## SERVICE LETTER 33

### CONVERSION OF MODEL 6000 TO MODEL 6100 FLOAT

<b>Aircraft Makes/Model(s):</b>	<b>Float Model(s):</b>	<b>Compliance:</b> Recommended	<b>By:</b> MAB
DHC-2 MK III	6000	<b>Part Number:</b> 1002411	<b>Approved:</b> SDW
		<b>Date:</b> 1/20/2020	<b>Revision:</b> C

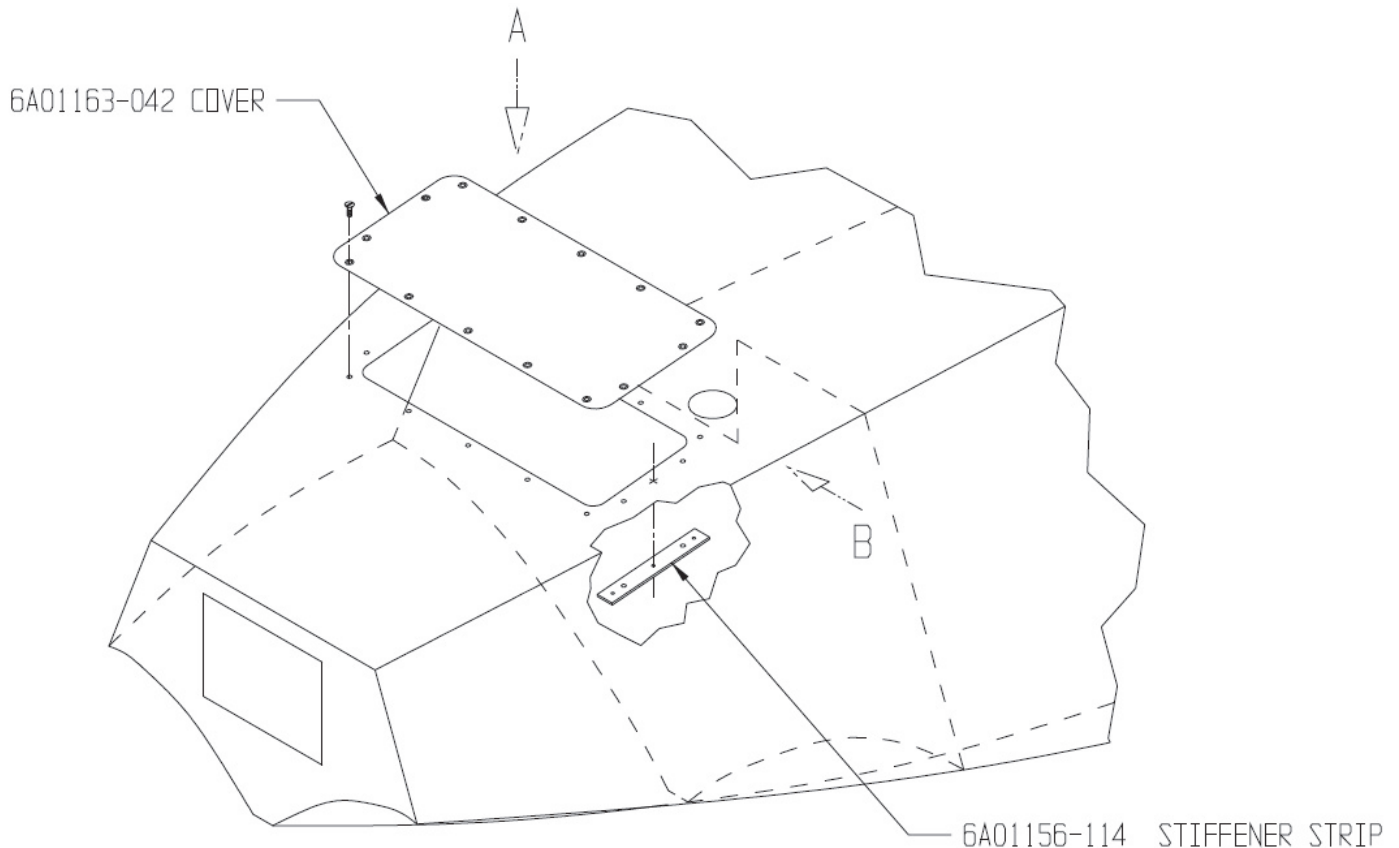
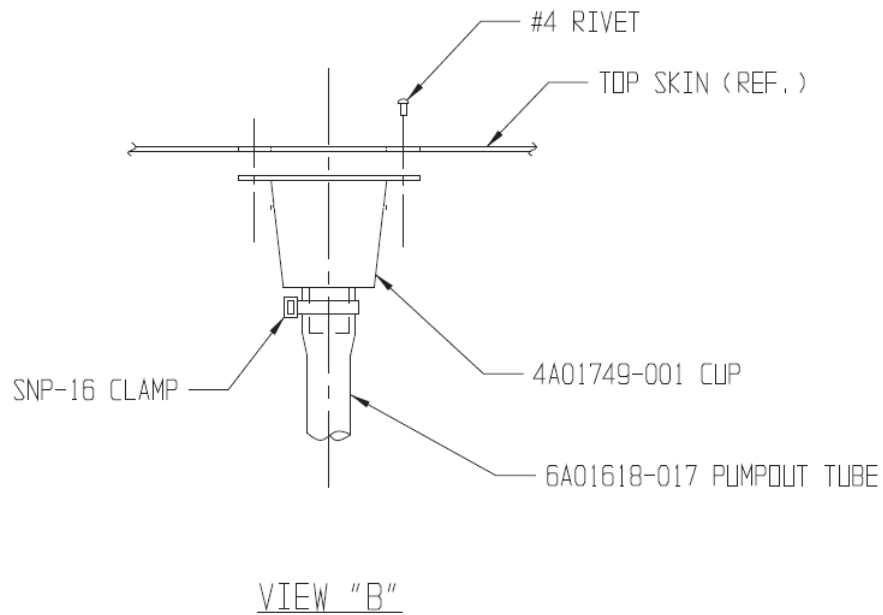
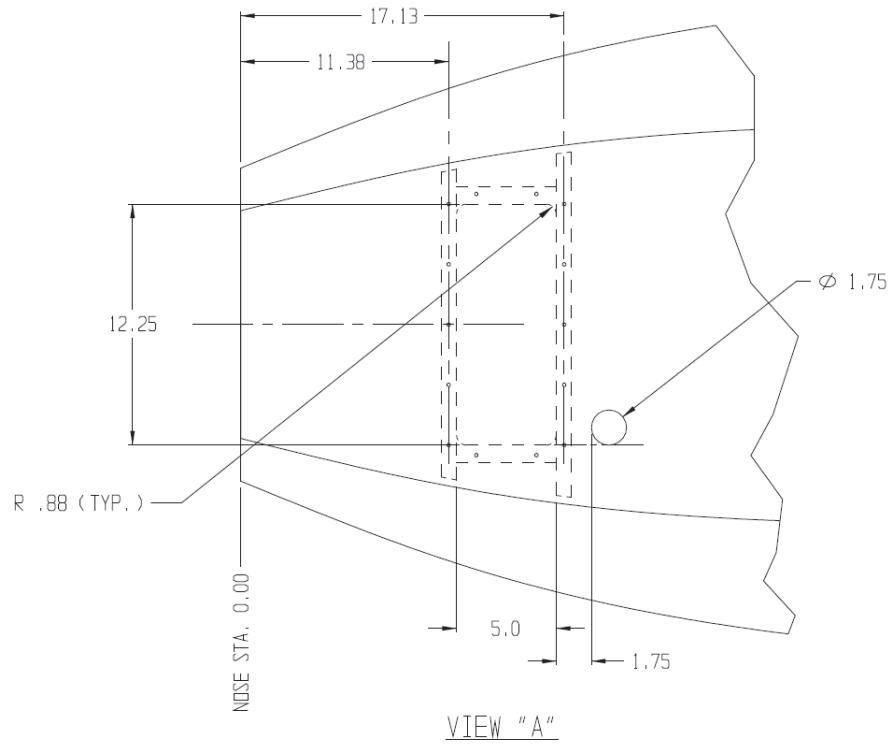
1. Drill out all rivets in top skin angles approximately 11.375 and 17.125 aft face of nose bulkhead.
2. Center template on top skin centerline.
3. Layout 5" X 12.25" hole on top skin and cut out between stiffeners.

4. Match drill #10 holes from template thru top skin and top skin angles for cover attach holes, #30 holes for nutplate attach.
5. Countersink all remaining holes in top skin and install AN426AD4 rivets.

6. Install 6A01156-114 strip under skin before installing 9A3-671 nutplates.
7. Locate 1.75 pump-out cup hole from template and install 3A01650-002 cup, 3A01650-002 ring. Rivet to topskin.

8. Install 3A01158-003 clamp on FWD side of #3 bulkhead, approximately 3" up from keel.
9. Install pump-out tube (20.5"). Secure top of tube to pump-out cup with SNP-16 clamp.

10. Install 9A3-671 nutplates and insulators to inside of top skin angles with AN426AD4 rivets.
11. Seal completely around #3 bulkhead. Water check after sealing.

12. If amphibious float, seal around nose box at #3 bulkhead. If seaplane float, install 6P01158-157 cover over nose box hole in #3 bulkhead. Match drill and secure with AN470AD4 rivets.

13. Apply caulking around cut-out and attach 6A01163-042 cover with #8 X 3/4" screws.
14. Amphibian floats, rework existing model 6000 shock struts with parts provided in kit while referencing current 6100 IPC and Service Manual.
